# PRELIMINARY DRAINAGE PLAN PUD/SP 22-X

## HILLSIDE AT LORSON RANCH

**JANUARY, 2022**

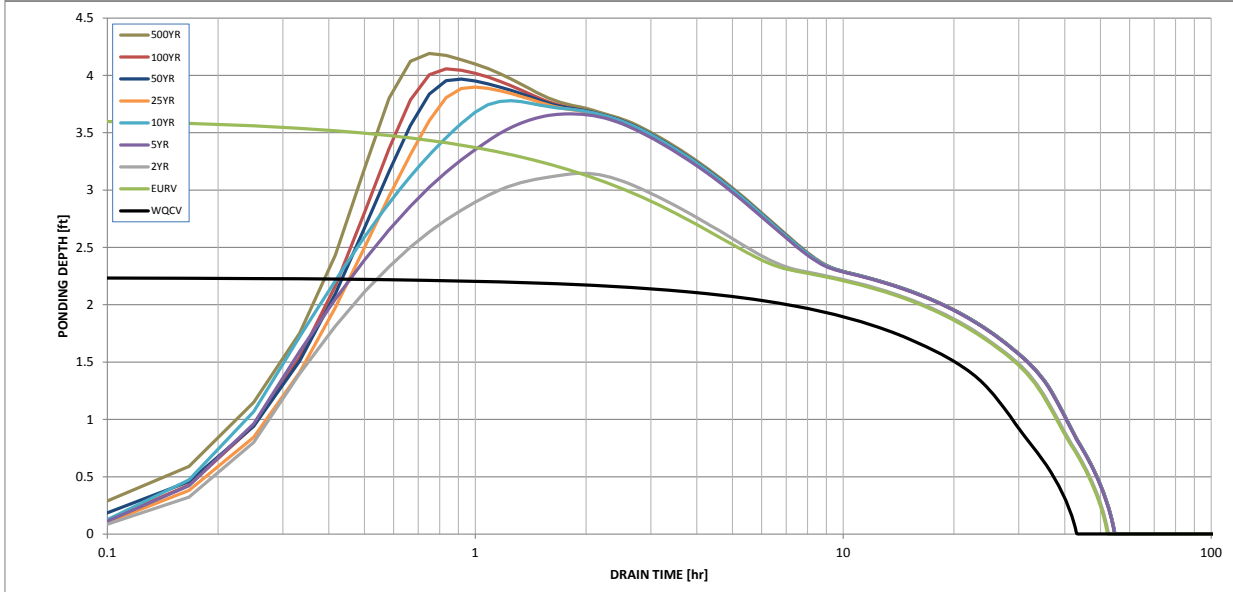
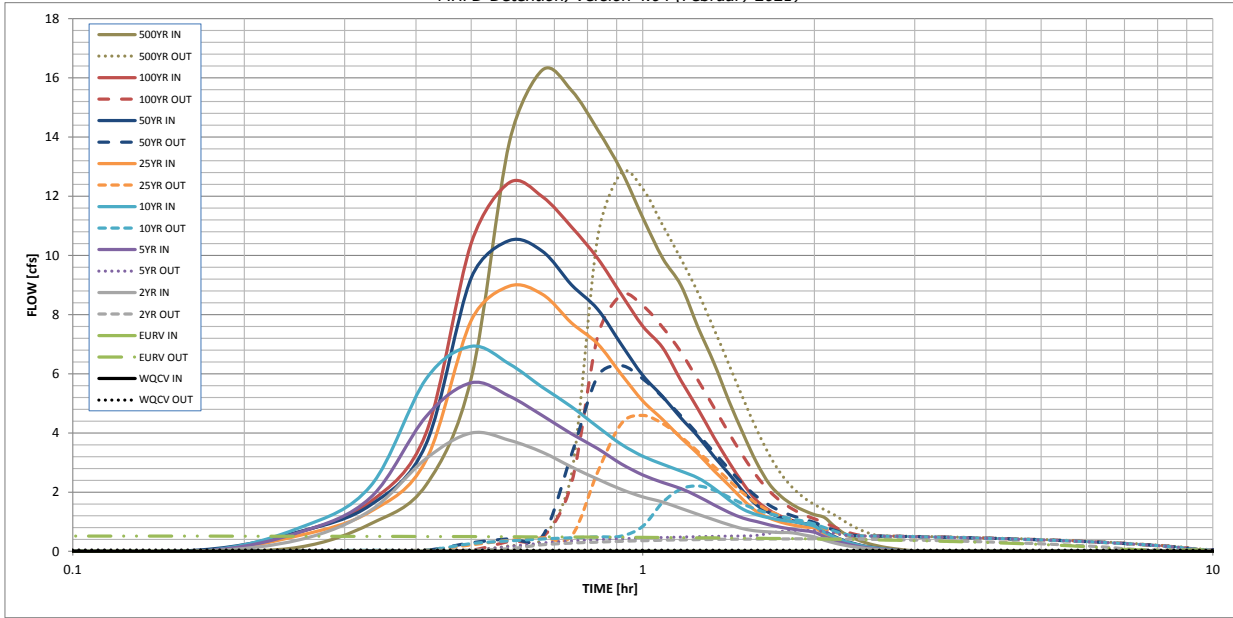
Add a note on this page to see discussion of DP43.

Per ECM Chap 3.2.8.B, "The proposed project or developed land use shall not change historical runoff values, cause downstream damage, or adversely impact adjacent properties." Increases from the historical flowrates is allowable (with or without full spectrum detention) if it is shown (via text and/or calcs) that the flow increase can be accommodated downstream (ie: show that there is a suitable outfall, per ECM, Chap 3.2.4). If applicable, reference the downstream facilities in a DBPS or MDDP.

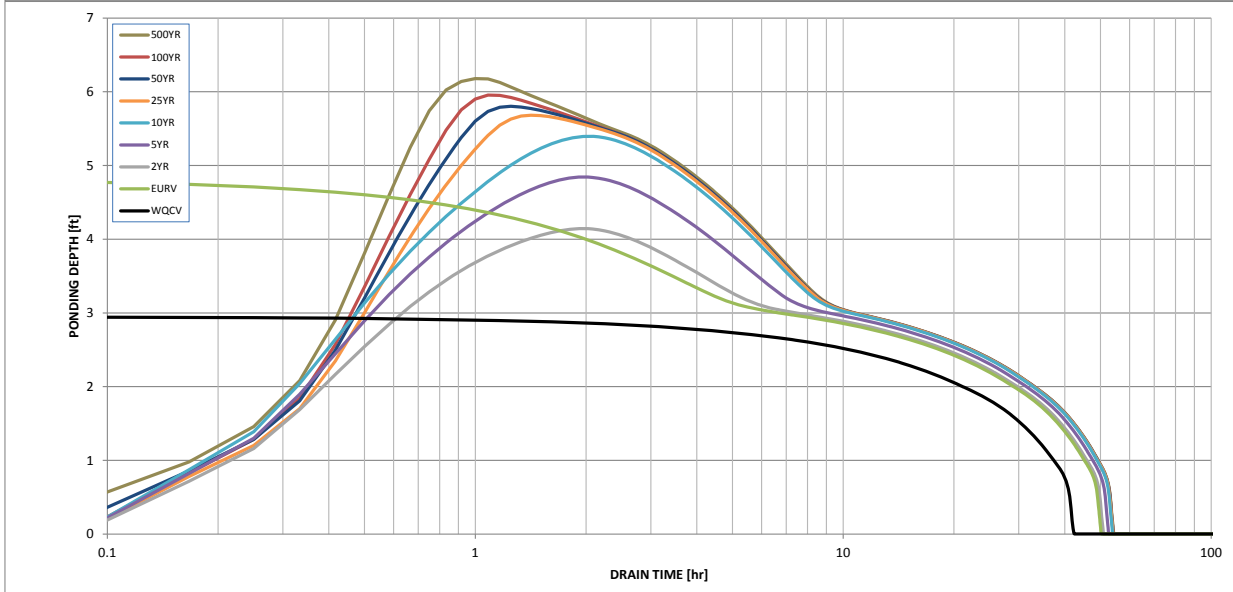
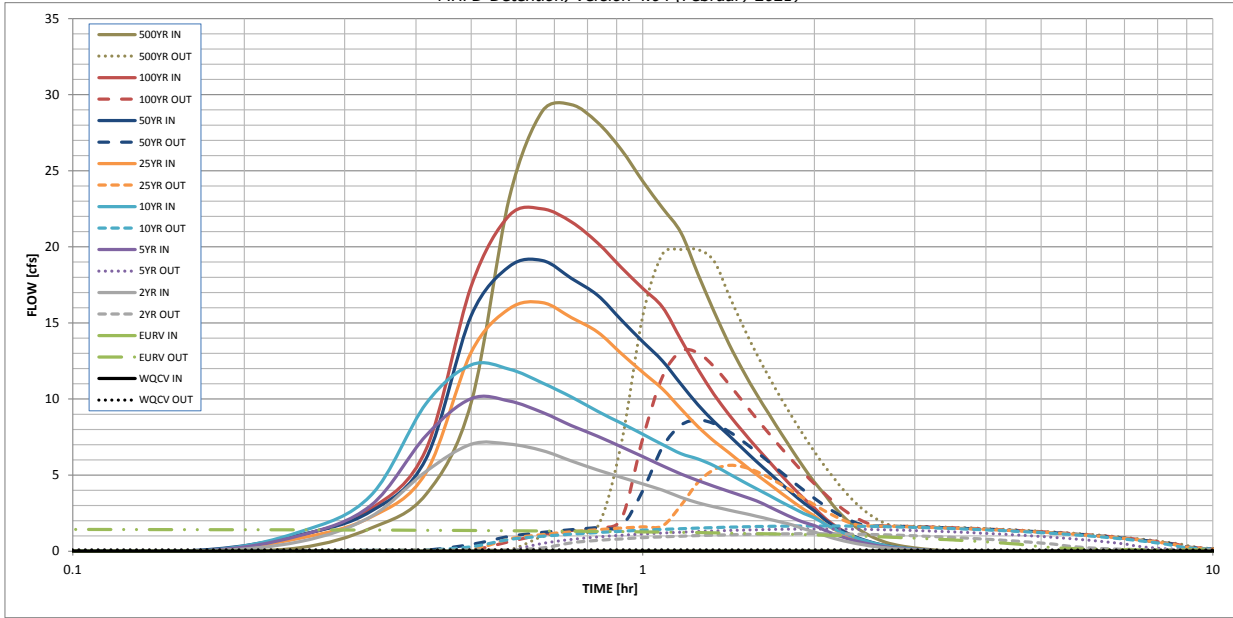
Add a note on this page to see discussion of DP5b.

Per ECM Chap 3.2.8.B, "The proposed project or developed land use shall not change historical runoff values, cause downstream damage, or adversely impact adjacent properties." Increases from the historical flowrates is allowable (with or without full spectrum detention) if it is shown (via text and/or calcs) that the flow increase can be accommodated downstream (ie: show that there is a suitable outfall, per ECM, Chap 3.2.4). If applicable, reference the downstream facilities in a DBPS or MDDP.

**WQ POND H  
POND DETAILS  
AND TRICKLE CHANNEL**

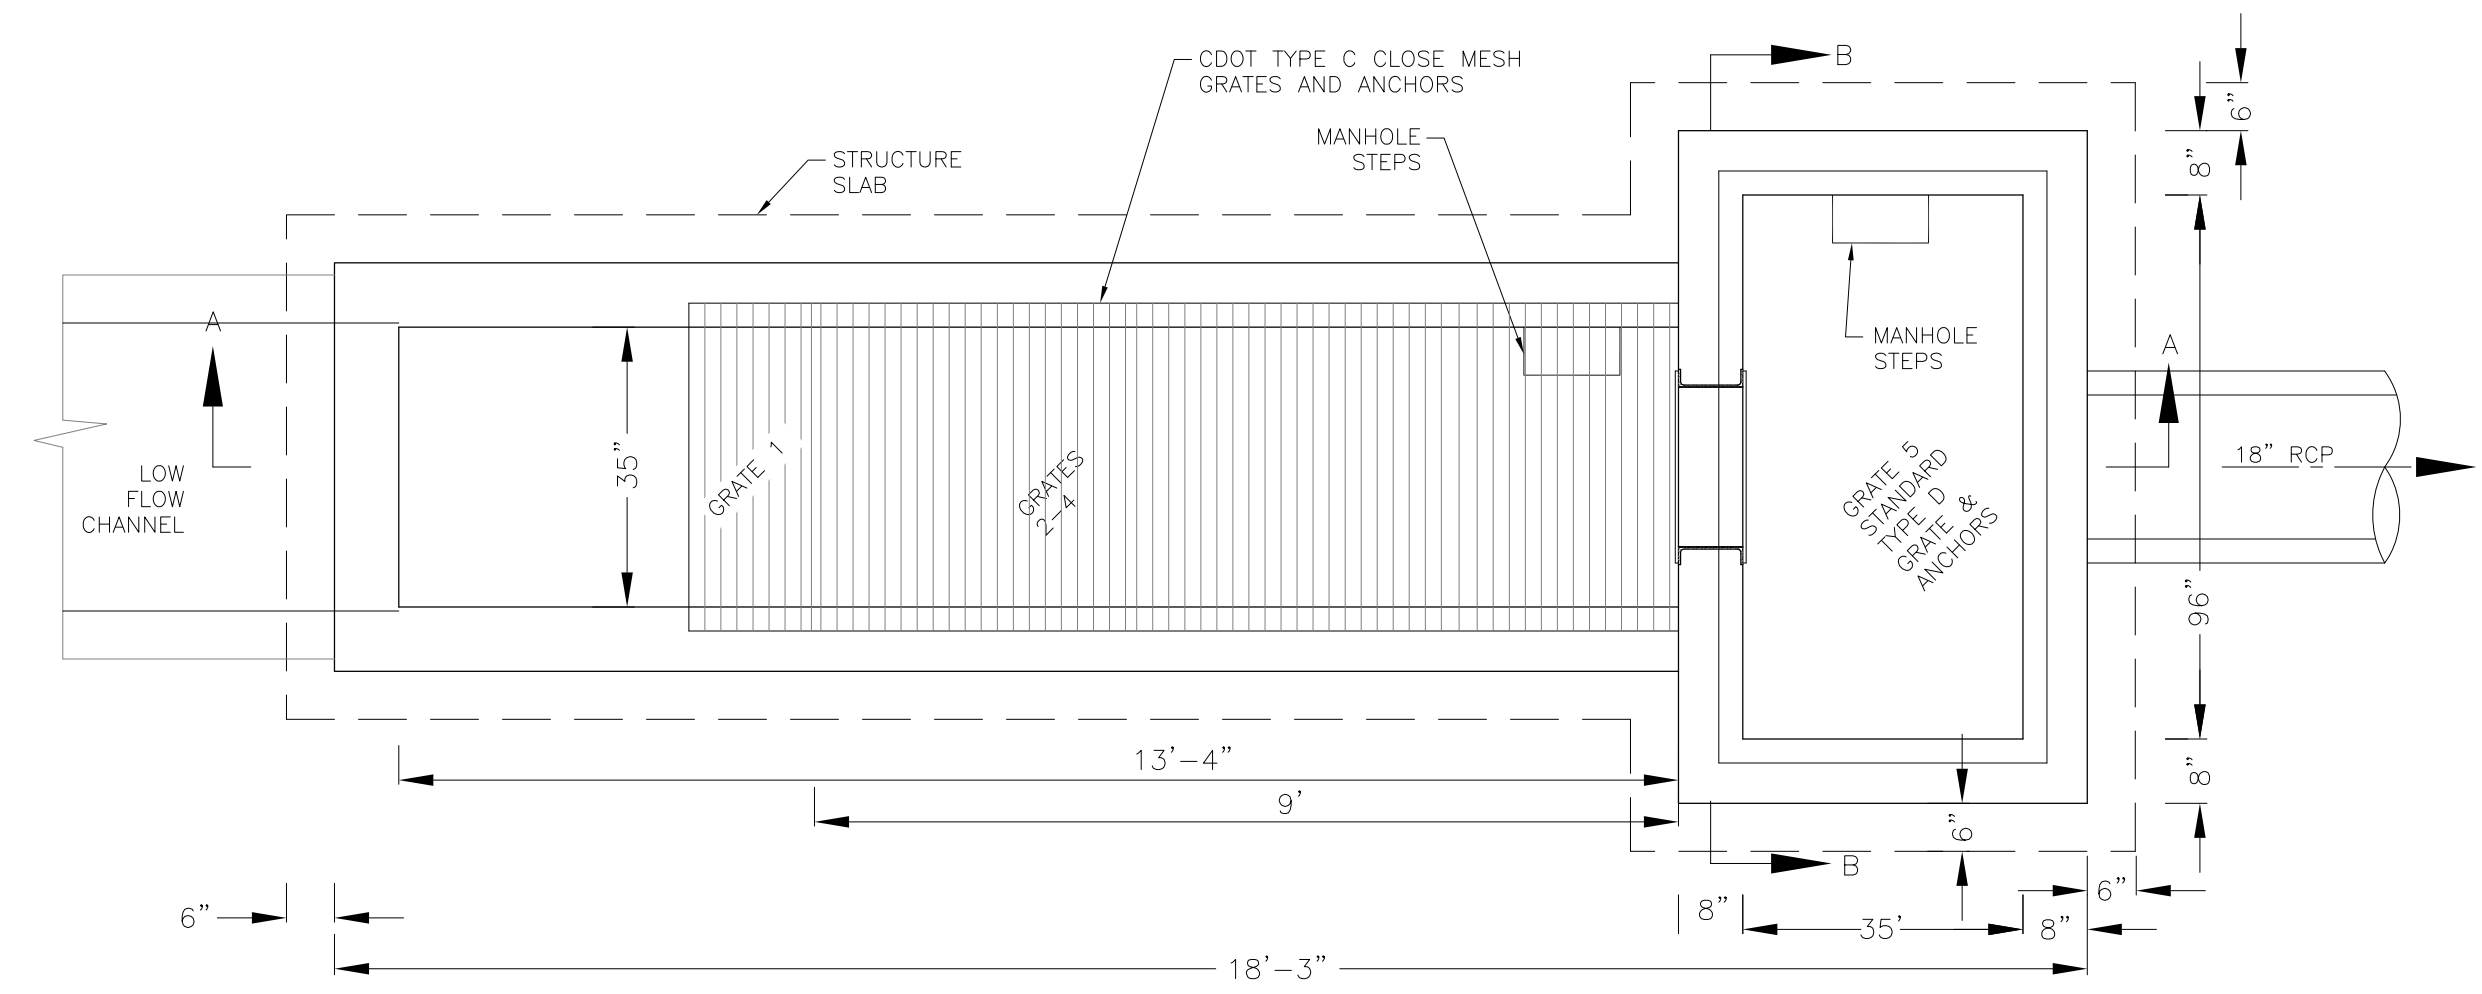
Attenuation?

**EXISTING CONDITIONS  
 PUD / PRELIMINARY PLAN  
 HILLSIDE AT LORSON RANCH**

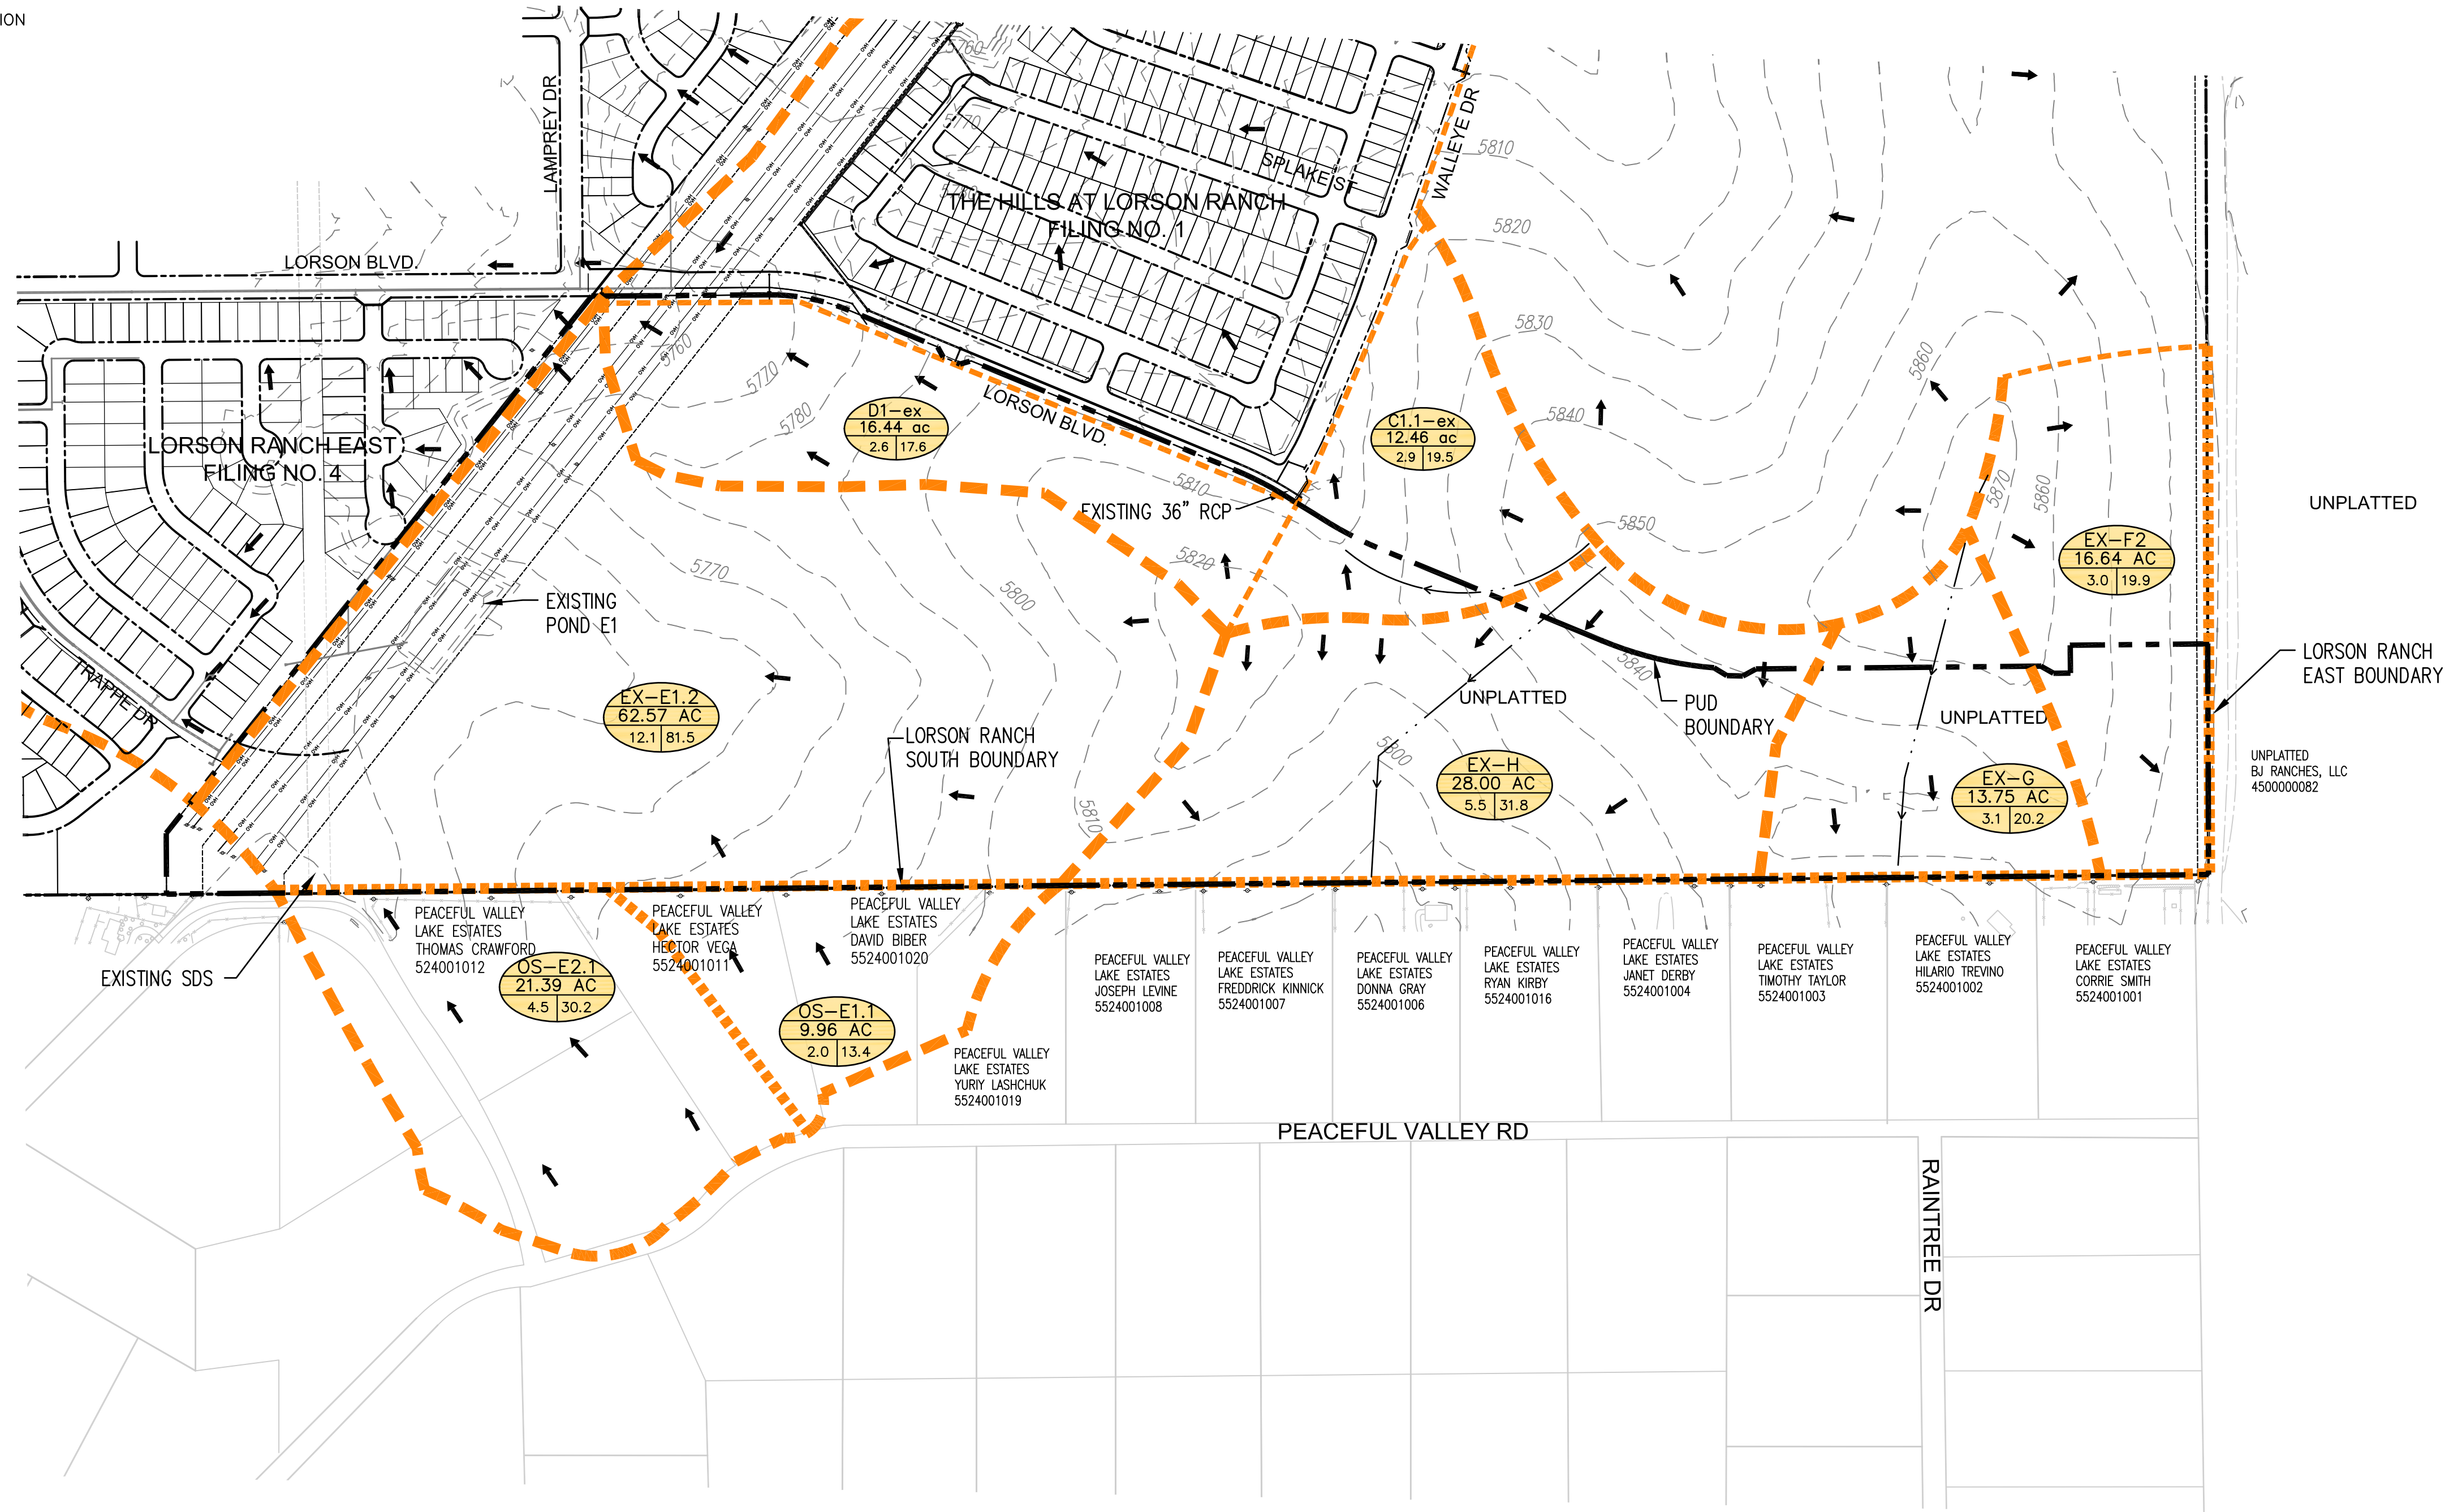
connected?  
Label existing pipes and which pond it flows to (Hills at Lorson D2?)  
Label existing inlets -- DP47c and d?  
Label D1.4  
Label to Pond C1

Add label for which pond this flows to (E2?)

Show maintenance access roads
